RX330/300

OUTLINE OF NEW FEATURES

The following changes are made for the new RX330/300.

5. Steering Pad Switch

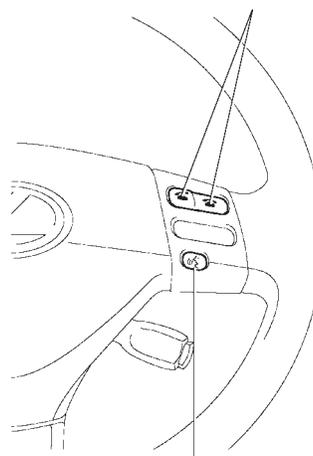
The steering pad switch RH is added.

- The steering pad switch RH in Europe models has two switches. One is for voice recognition function of the LEXUS navigation system. The other is for the Bluetooth type cellular phone.
- The steering pad switch RH in other models has a switch. This is for voice recognition function of the LEXUS navigation system.

For Bluetooth type Cellular Phone

For Recognition Function
(Europe Models)
